**Report: TAB Punchlist**  
**Function: Test, Adjust, & Balance**  
**Date: 05/29/2025**  
**Completed By: National TAB**

**PROJECT**  
**05-26-25 FREDDYS ELKHART, IN**

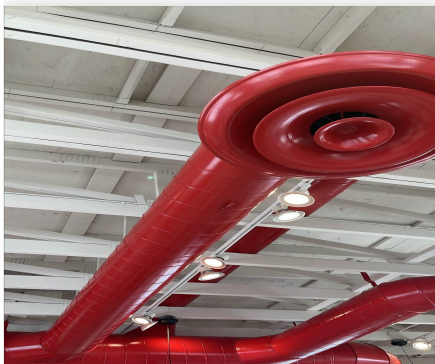
**Issue Name :** Diffuser 1-6 low on flow  
**Description :** RTU-1 diffuser 1-6 is low on flow, this could be to it being the first duct run closest to the supply drop causing airflow to shoot passed it, can install a scoop inside the ductwork to help direct airflow to this diffuser. Not anticipated to cause any issue.  
**Created By :** National TAB                      **Assigned To :** National TAB - Dylan Crisman  
**Status :** Open  
**Priority :** Medium                                      **Asset Tag :**  
**Originated Date :** 05/29/2025 - Dylan Crisman - National TAB

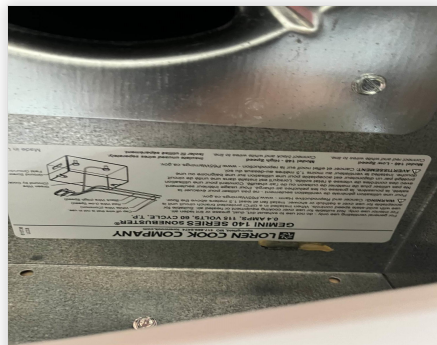
**Issue Name :** EF-1/EF-2 high on flow  
**Description :** EF-1/EF-2 are high on flow at 99/75CFM and 94/75CFM. Units have been rewired for low speed and cannot be reduced further. Not anticipated to cause any issue.  
**Created By :** National TAB                      **Assigned To :** National TAB - Dylan Crisman  
**Status :** Open  
**Priority :** High                                      **Asset Tag :**  
**Originated Date :** 05/29/2025 - Dylan Crisman - National TAB

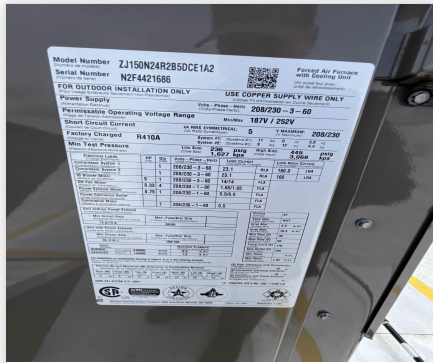
**Issue Name :** RTU-1 ALARM  
**Description :** RTU-1 alarm reads “using return air instead of space temp” recommend mechanical check wiring on space sensor and at unit for short/loose wire to correct.

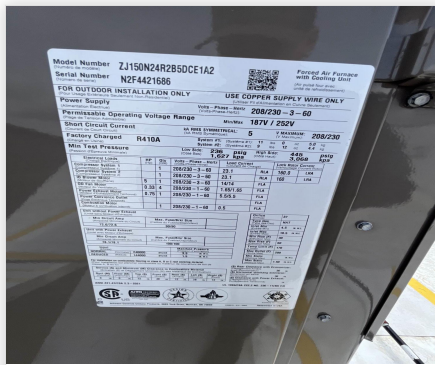
**Issue Name :** RTU-1 Final Filters  
**Description :** RTU-1 has construction filters installed. Recommend replacing with correct size (20x24x2) merv 8 rated pleated filters.  
**Created By :** National TAB                      **Assigned To :** National TAB - Dylan Crisman  
**Status :** Open  
**Priority :** Low                                      **Asset Tag :**  
**Originated Date :** 05/29/2025 - Dylan Crisman - National TAB
